Development Services Department

PRJ-1165197 – Alternatives to Maneuvering Space Requirements through Equivalent Facilitation

Board of Building Appeals and Advisors – 9/10/2026
Meeting

Ali Fattah, Assistant Deputy Director, DSD

Figure 11A-8A Maneuvering Clearance - Doors

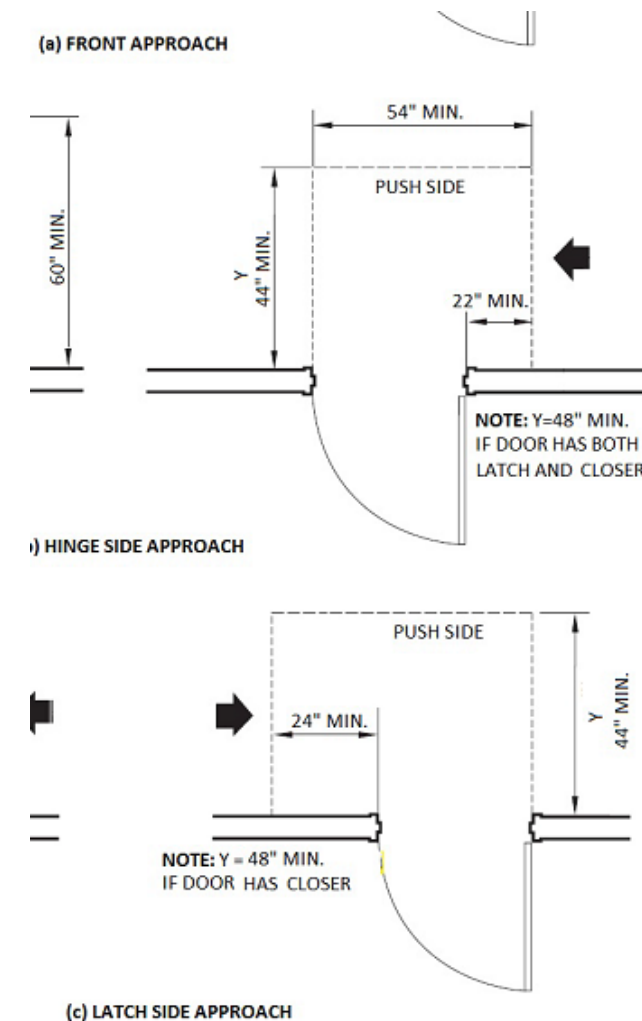
48-inch-deep landing is not required since a closer is not required on doors accessing zero hour rated corridors.

- Fair Housing Act (FHA) and CBC Ch 11A intend for dimensions to be measured from face of wall.
- 44 inch landing depth requirement unique to California
- FHA and ADA require 42 inches.
